## Eugene Hearings Official

# AGENDA

##### **Cottage Mart (CU 14-2)**

##### **The Springs at Greer Gardens (CU 14-1/Z 14-1/SR 14-1/ARA 14-1)**

# The Springs at Greer Gardens - Site Plan

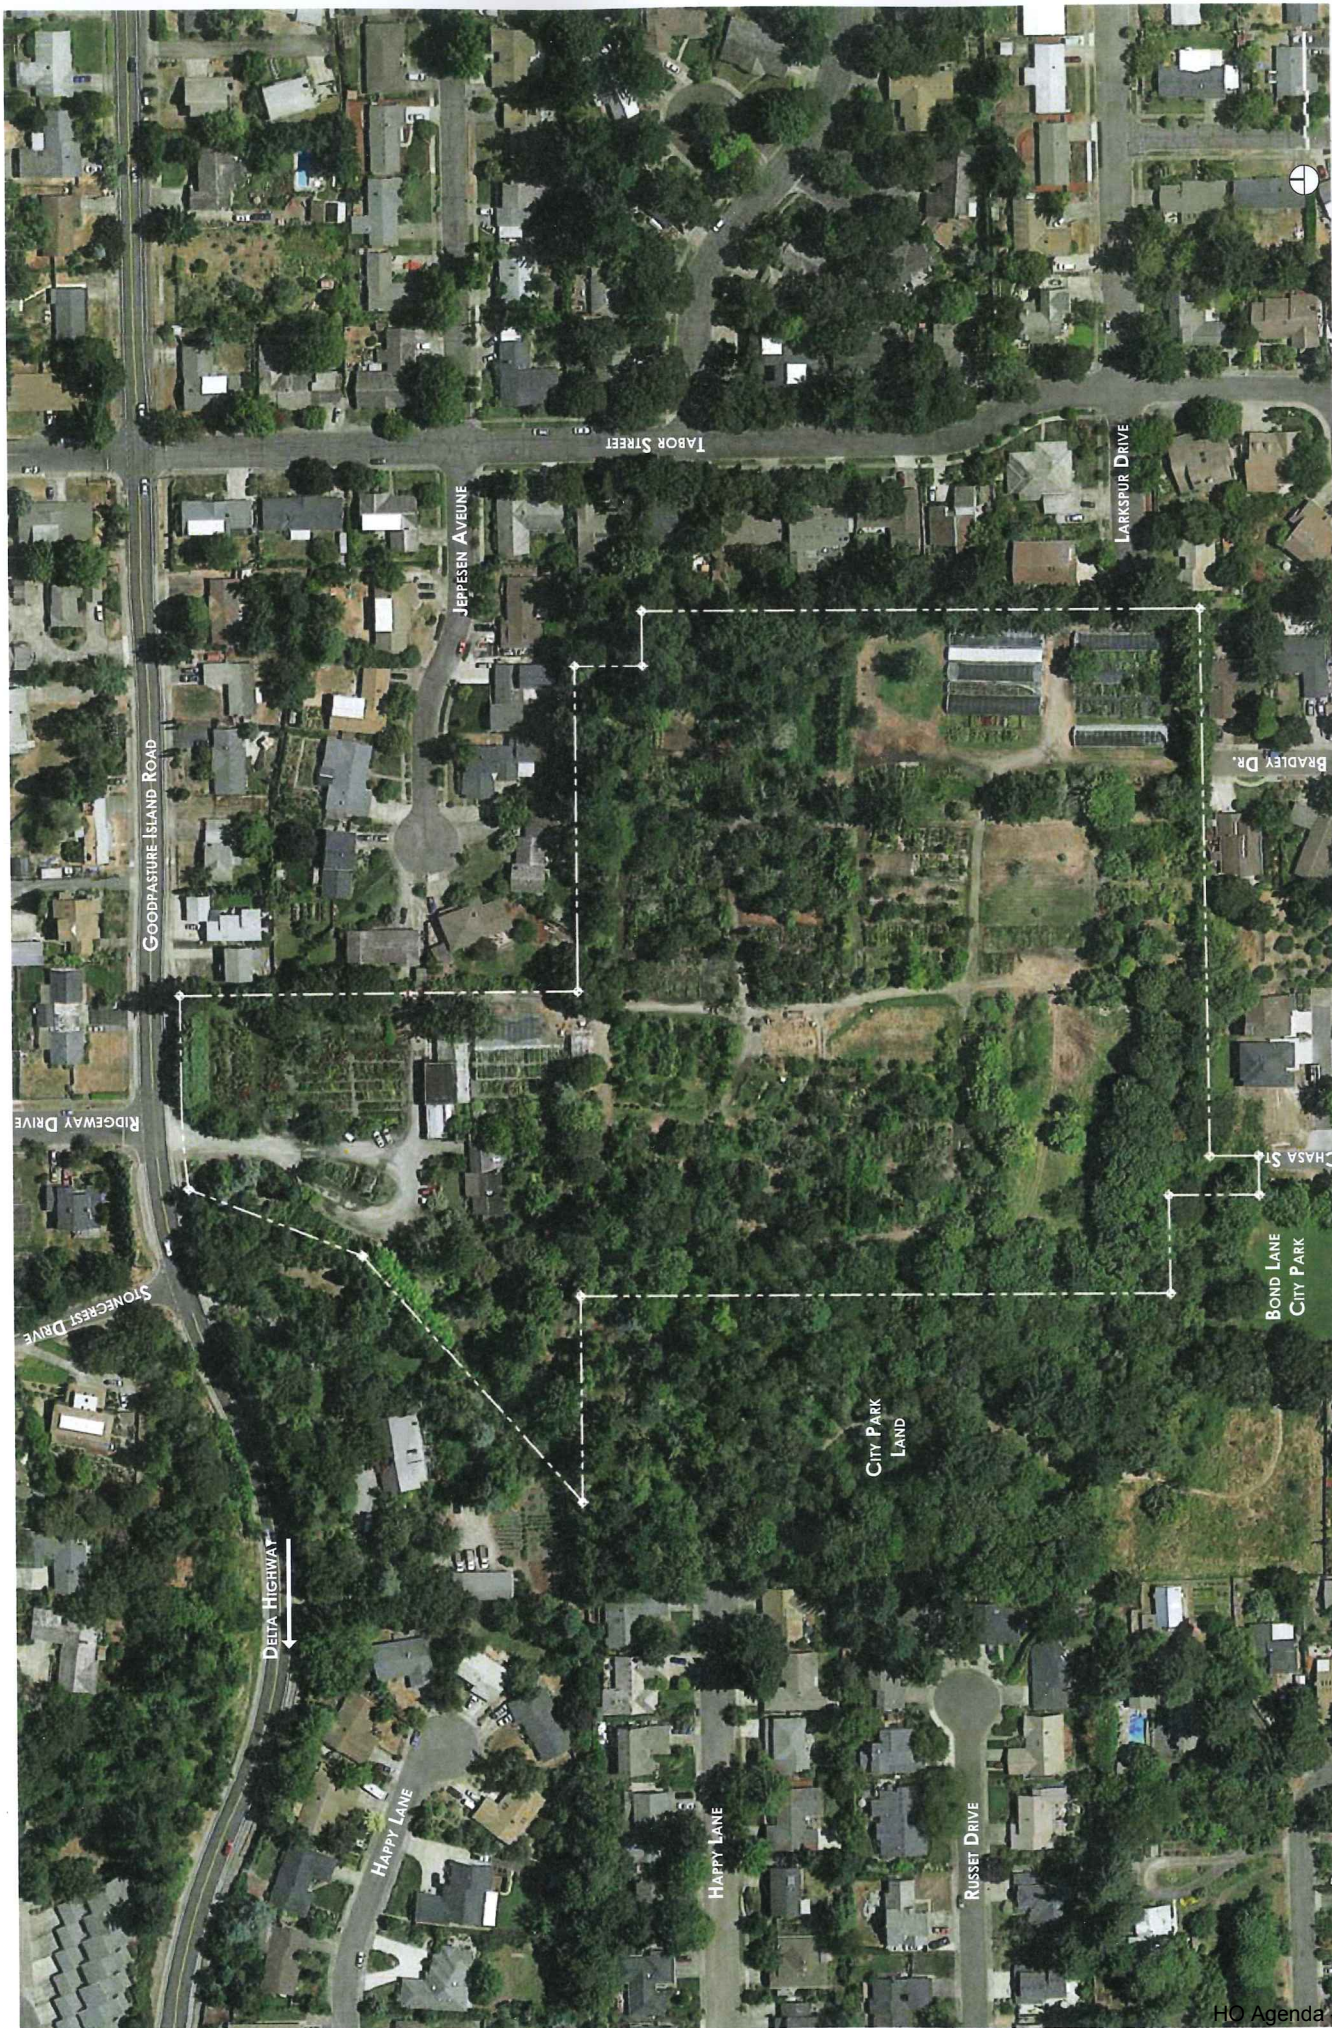
As shown on the applicant's survey map (Sheet A5), the site is gently sloped with some depressed areas (ditches) scattered across the property, some of which have intermittent pipes. The applicant's grading plan (Sheet C1) shows that the depression in the northwest corner of the site will be reconfigured to maintain the natural drainage of the site, but to prevent sheet-flow of stormwater runoff onto adjacent lands. This proposed drainage collection area will receive stormwater overflow from the development, which will first be treated and detained by the proposed on-site stormwater management infrastructure, before discharging to the adjacent parkland.

Existing trees on the subject property are shown on Sheet L2 of the applicant's plans. Trees proposed for removal are primarily located within the footprint of the development, leaving the perimeter trees virtually intact. As indicated in the applicant's assessment provided on Sheet L3, only trees with health issues are being removed along the perimeter of the site. The bulk of the larger trees on the site are located along the eastern property boundary, which the applicant proposes to preserve by providing generous setbacks from the development.

The applicant's landscape plan (Sheet L1) shows substantial tree planting throughout the site, with particular attention to the perimeter of the property. Although no comparative total has been provided regarding the number of trees proposed for removal and replacement, the applicant's plans illustrate that the proposed plantings will be at least equal to the amount of

The bollards at Larkspur Drive will enable pedestrian and bicycle crossings of the site. Additionally, the applicant proposes pedestrian connections to the parkland to the west. The applicant's plans also show pedestrian connections in the direction of Chasa Street and Bradley Street, although the proposed perimeter landscaped screening would prevent physical access. Public Works staff notes that a bicycle and pedestrian connection from Chasa Street is necessary to provide better access to Bond Park. In accordance with EC 9.6835 Public Accessways, the following condition of approval is necessary:

- The final site plan shall be revised to show the proposed pedestrian connection in the direction of Chasa Street to connect all the way to the street and to omit any physical barrier, such as landscaping and fencing, to bicycles and pedestrians.

- The final site plans and all subsequent permit plans (i.e. site development, PEPI, and building permit) shall delineate the critical root zones (CRZ) of all preservation trees and show protective fencing to be in place outside the CRZ during construction activities. The plans shall note that no fill, building or other construction related impacts are allowed within those tree protection areas.
- The final site plans shall note the following: No grading, filling, or development is allowed prior to establishment of the tree protection fencing, which must be verified by City staff that it has been installed in accordance with the approved plans. All tree protection fencing shall remain in place until the completion of all construction activities and final zoning inspection has been approved.

- The final site plans shall note the following: Removal of dead, diseased, or hazardous trees shall be allowed with documentation from a certified arborist as to the condition of the tree and the need for removal. Documentation must be provided to the City for review and approval prior to tree removal activity.

- The final site plans shall note the following: In the event a preservation tree must be removed, the justification of the removal must be documented by a certified arborist. Documentation must be provided to the City for review and approval prior to tree removal activity. The tree shall be replaced at a ratio of two (2) trees for each one (1) tree removed. Replacement trees shall be native species, with a minimum caliper of 2 inches for deciduous canopy trees and a minimum height of 5 feet for coniferous or evergreen trees. Replacement trees shall be the same species and be planted within the Critical Root Zone of the preservation tree removed unless otherwise approved by the City.
